GULF STATES UTILITIES COMPANY

November 5, 1984
RBG- 19,354
File Nos. G9.5, G9.19.2

River Bend Station - Unit 1
Docket No. 50-458

RESPONSES TO REQUESTS FOR INFORMATION
IN SECTIONS 2.2, 2.3, AND 2.4 OF ENCLOSURE 3
TO NRC DECEMBER 22, 1980 LETTER

FIGURE 4
 RIVER BEND STATION
 HEAVY LOAD DROP IMPACT REGIONS
 REACTOR BUILDING/AUXILIARY BUILDING, EL 141'-0"

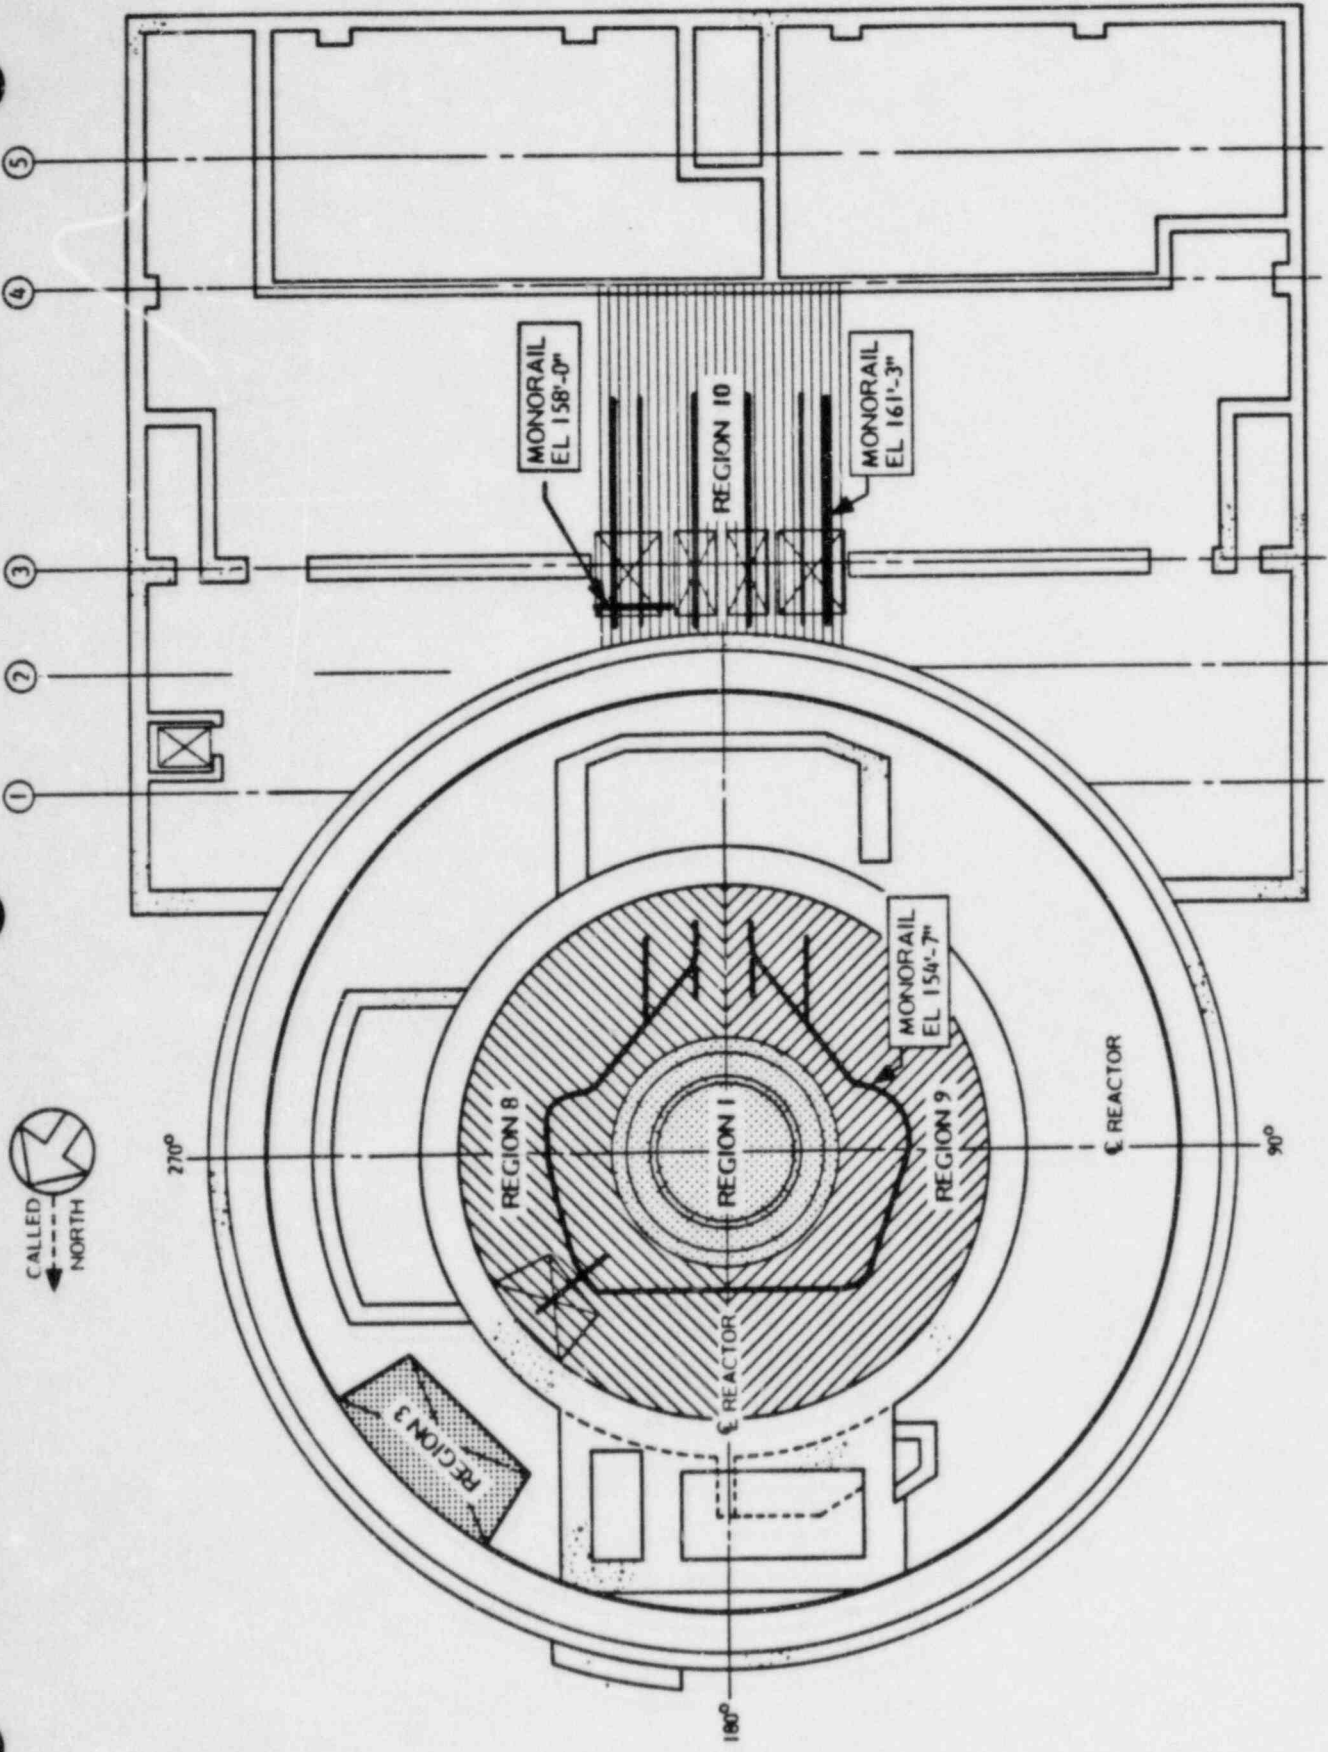
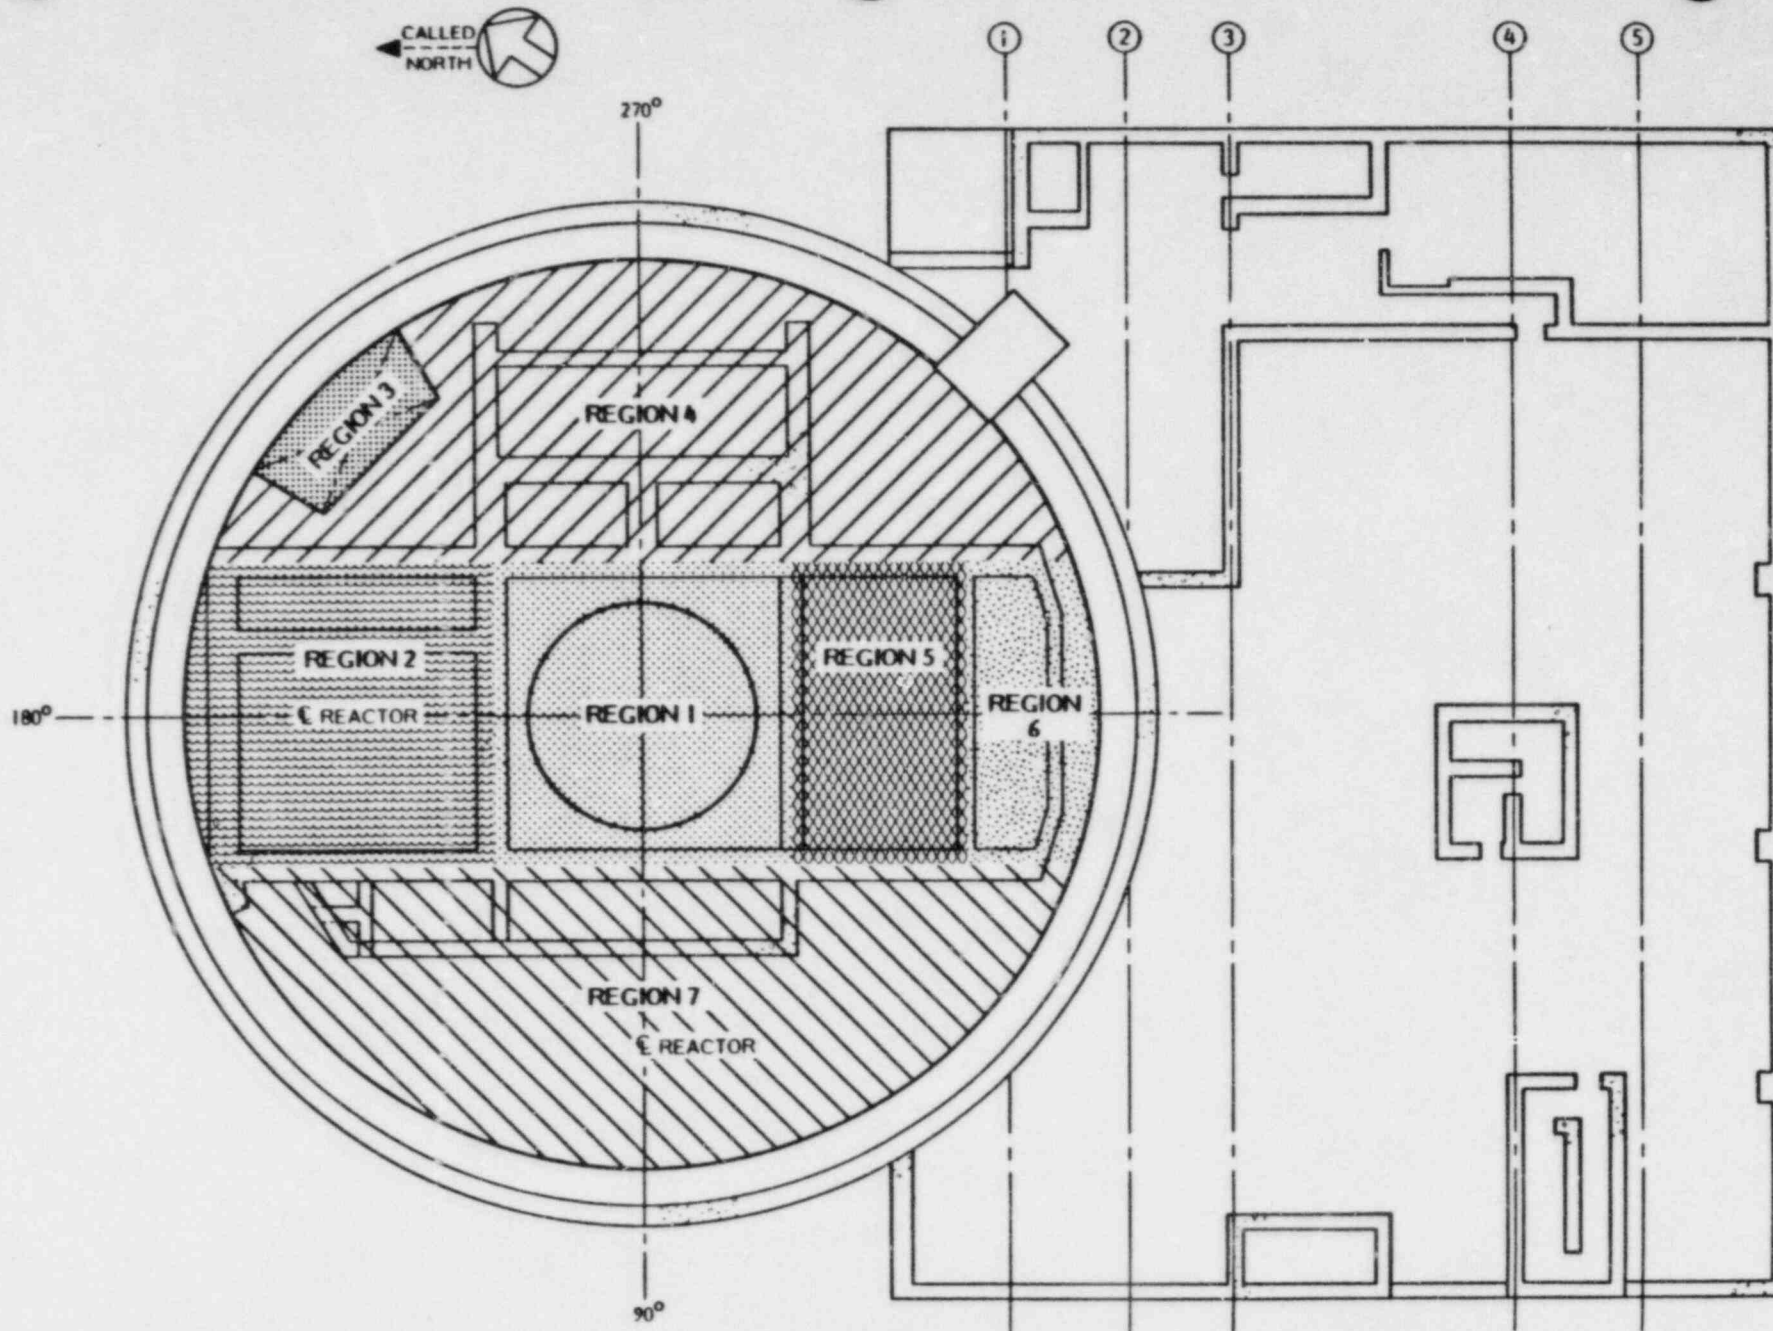
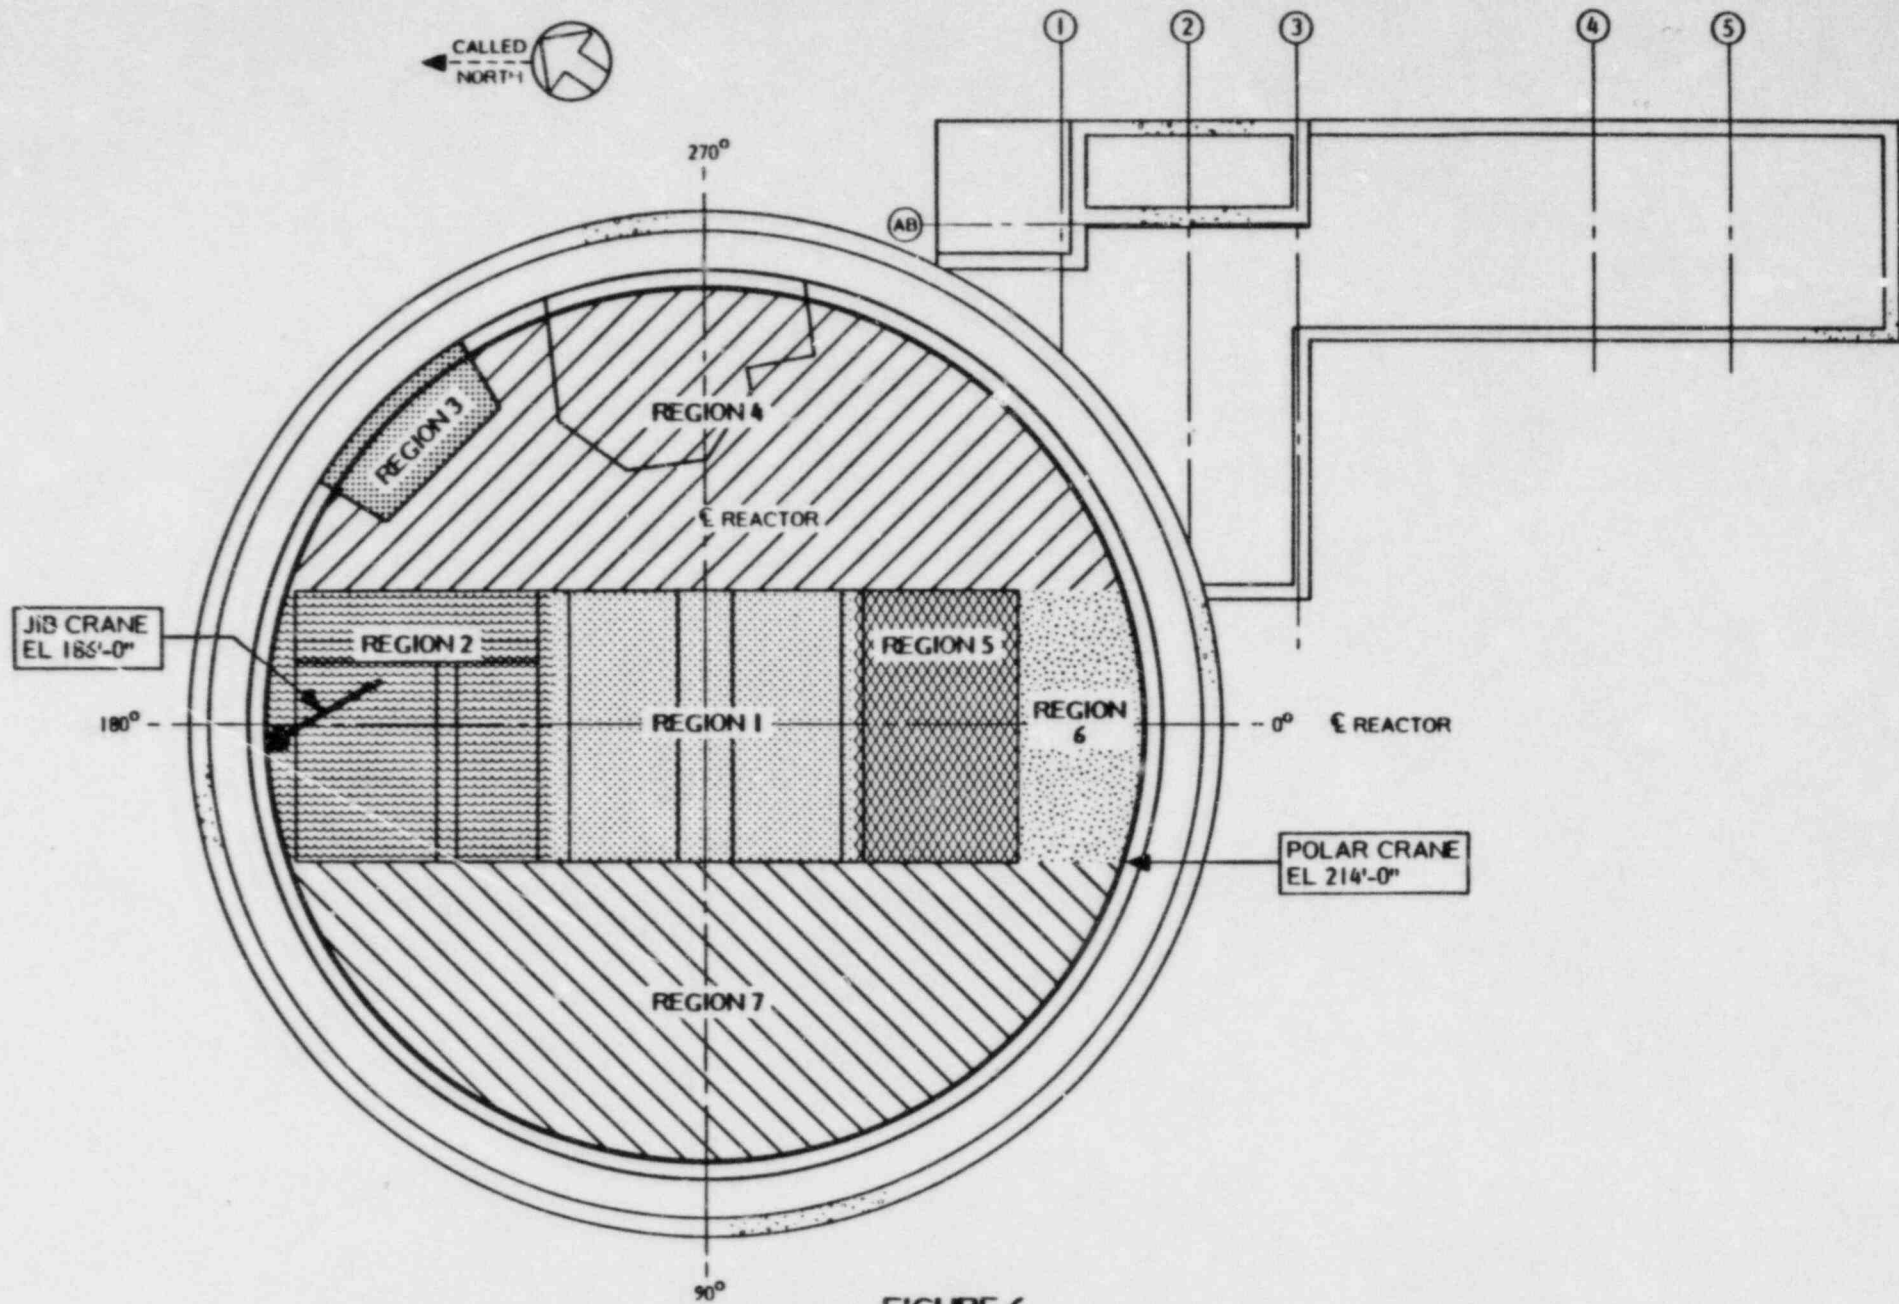
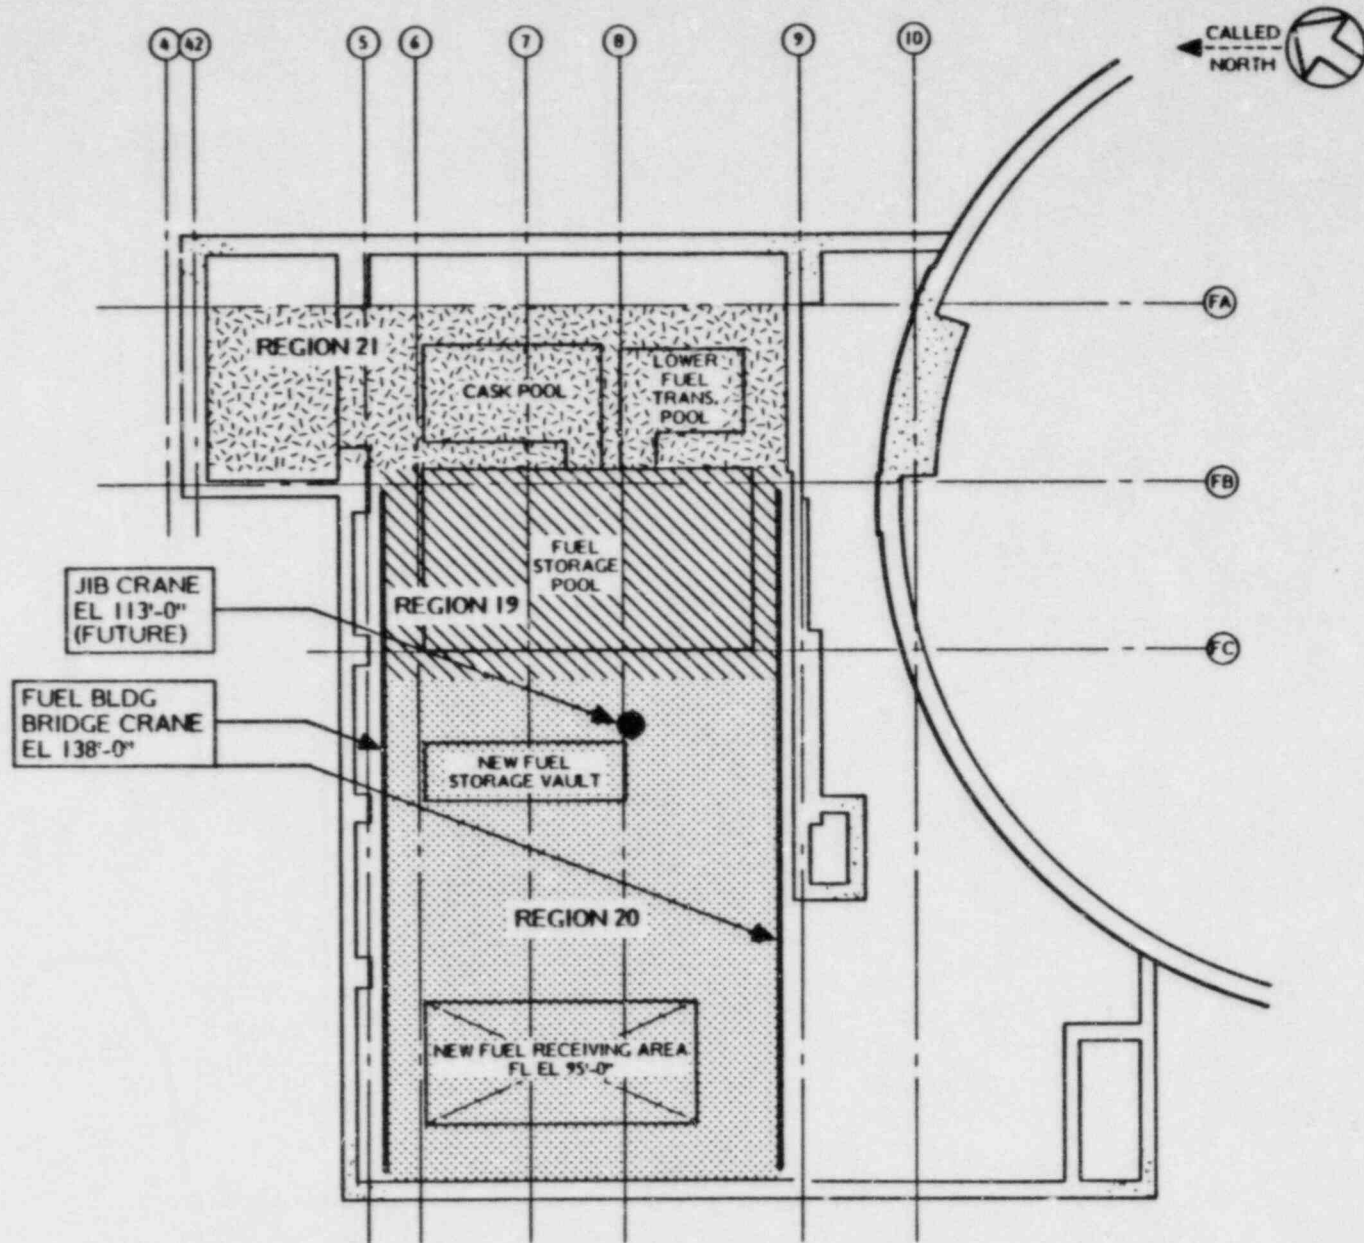
ITEM 2.4.2 For any cranes identified in 2.1-1 not designated as single-failure-proof in 2.4-1, a comprehensive hazard evaluation should be provided which includes the following information:

- a. The presentation in a matrix format of all heavy loads and potential impact areas where damage might occur to safety-related equipment. Heavy loads identification should include designation and weight or cross-reference to information provided in 2.1-3-c. Impact areas should be identified by construction zones and elevations or by some other method such that the impact area can be located on the plant general arrangement drawings. Figure 1 provides a typical matrix.

RESPONSE: Table I identifies the potential impact regions and the associated load handling systems. The loads corresponding to these handling systems were previously identified in response to item 2.1-3c. Figures I through II further describe the potential impact regions. For the handling systems identified in Table I (also listed in 2.4.1 above) a combination of systems and structural evaluations was utilized to determine if Criteria IV of NUREG-0612 is met for all postulated load drop scenarios. To assist these evaluations, a set of safety functions were identified corresponding to these criteria. The goal of these evaluations then became to demonstrate that the applicable safety functions could be accomplished for all load drop scenarios.
